C2C return loss and test fixture

Some related issues with C2C spec

Showing the Clause 137 channel return loss limit

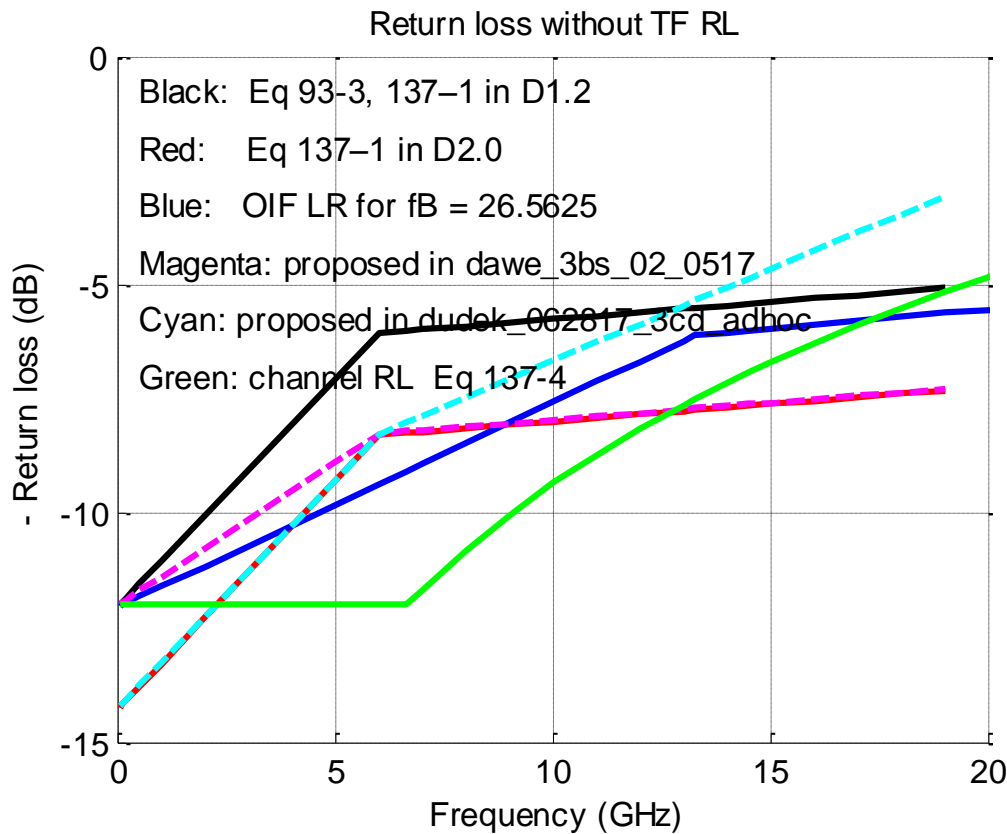
- Channels have lower return loss than this at very low frequencies – but that doesn't mean we need to adjust the spec there
- Should any C2C channel RL spec be the same as Cl. 137 -KRn?
- Should it apply to all channels, or e.g. only if $COM < 4$ or 5 dB?

Adjusting for test fixture IL but not its RL

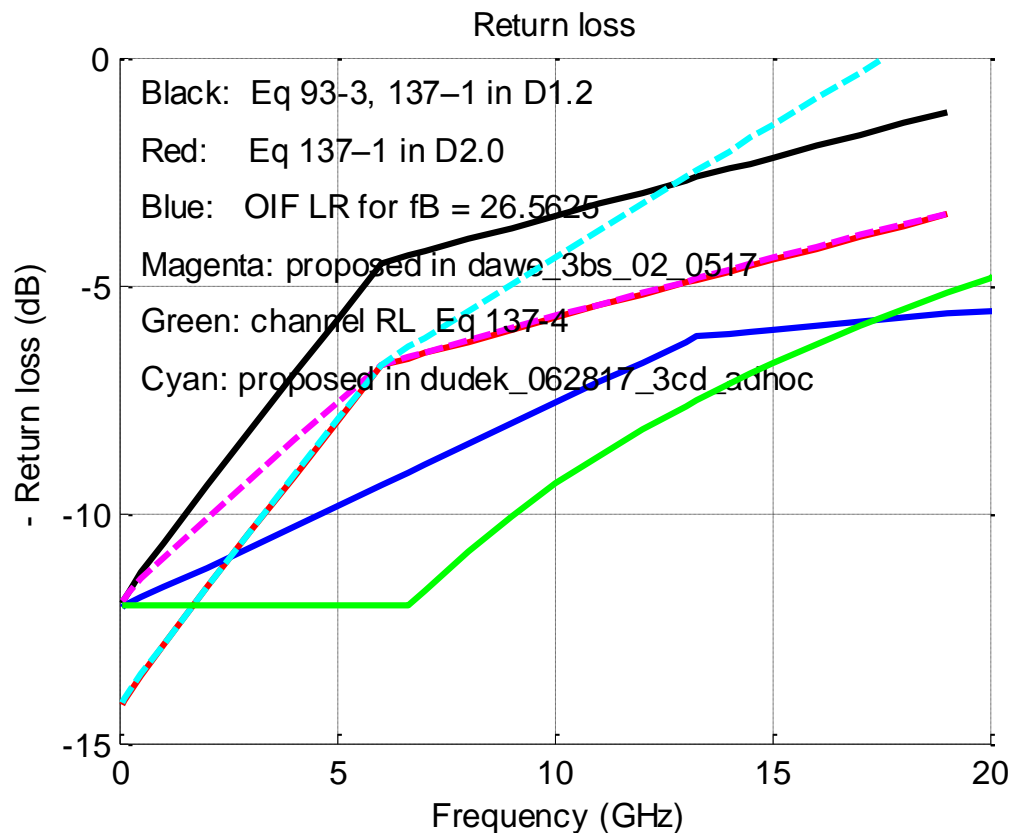
- Compare previous slide
- Red and cyan are too tight at low f
- Cyan is too loose at high f
- Black is too loose at mid f
- Green – compare next two slides

Channel return loss

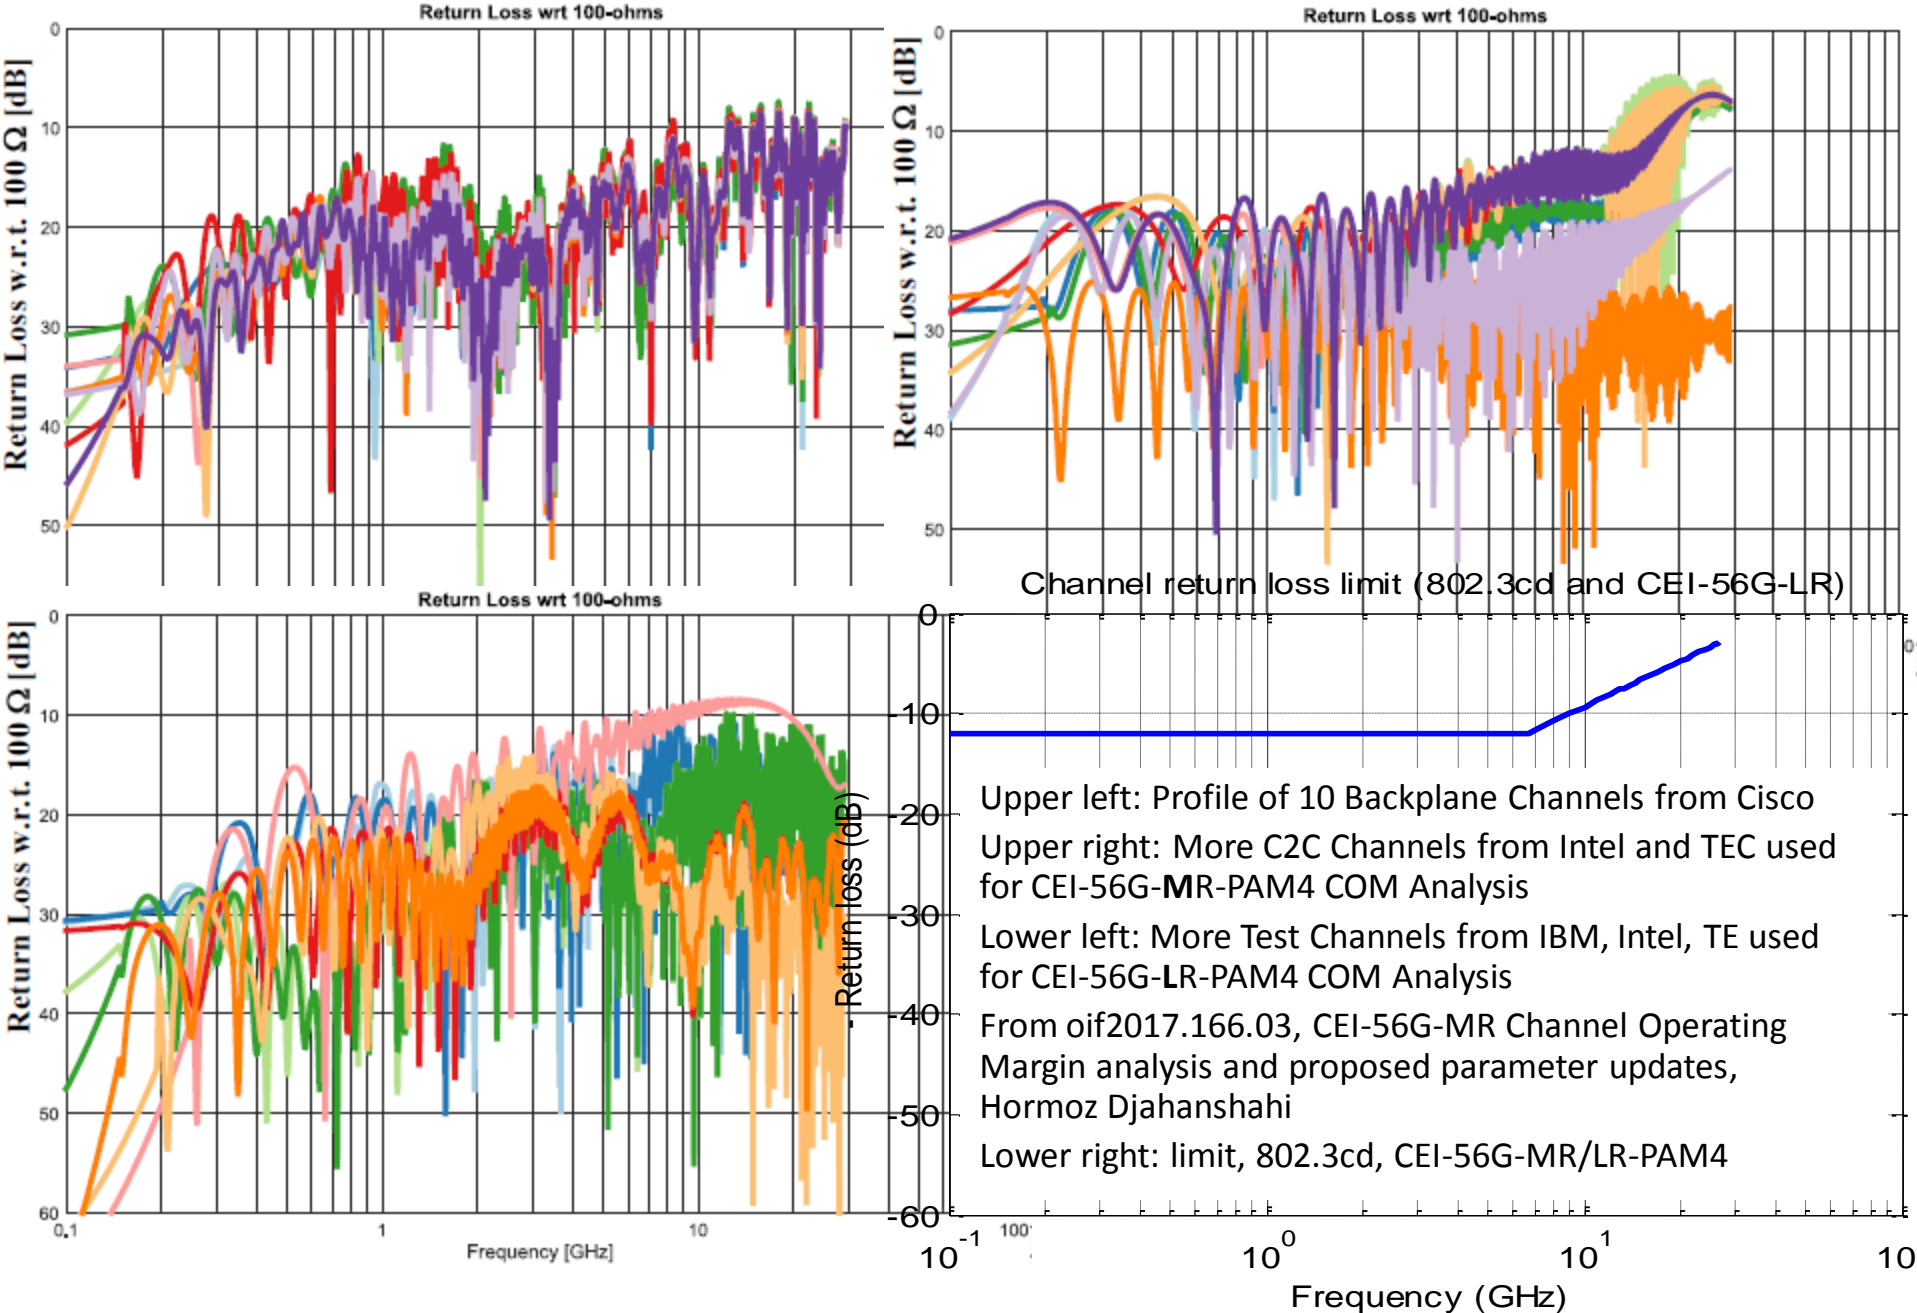
- Channel return loss (at TP0 or TP5) from 802.3cd Eq. 137-4 and OIF
- CEI-56G-MR-PAM4 Eq 17-3 and LR-PAM4 Eq 21-3 (*but not C2C*)
- *C2C needs a channel RL spec, otherwise the Tx RL spec is not very useful*

2. Backplane/C2C test fixture RL

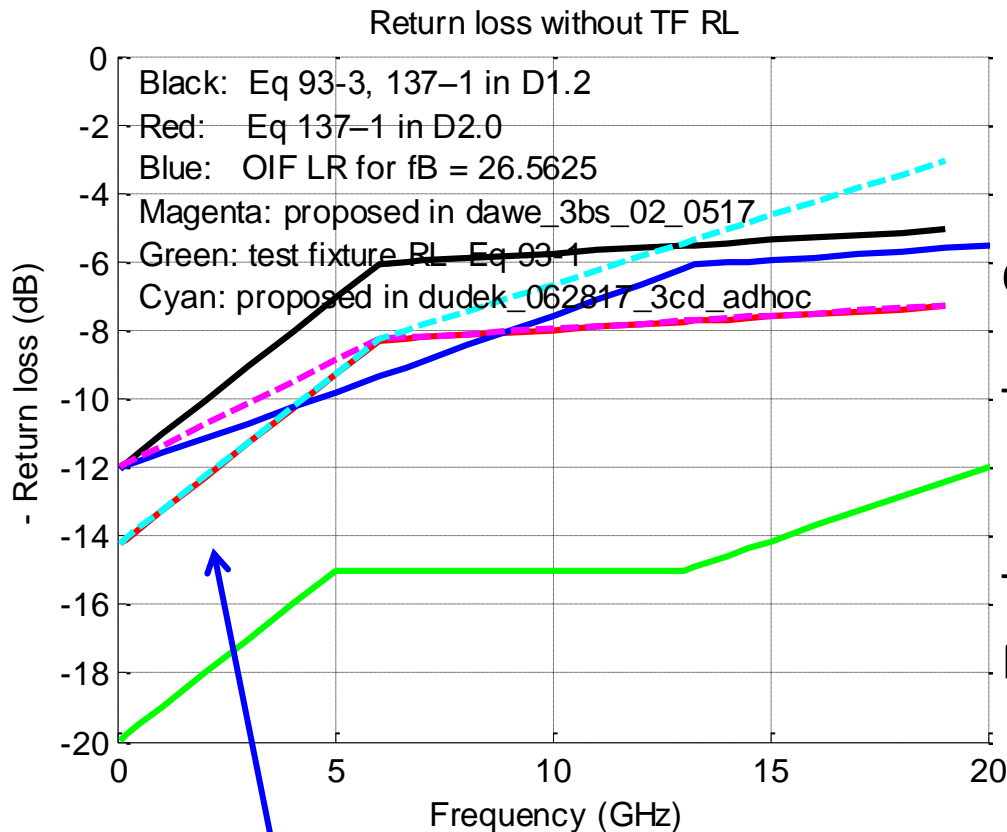
The gap between spec RL and TF RL is too small

If the apparent RL is given by the red line, and the test fixture has allowed reflections per green line, the IC on the test fixture has to be **much** better than intended

Changing from black to red made this issue worse

The problem is worst at low frequencies, and for the red and cyan lines

De-embed the return loss differences too, or tighten the TF RL spec?
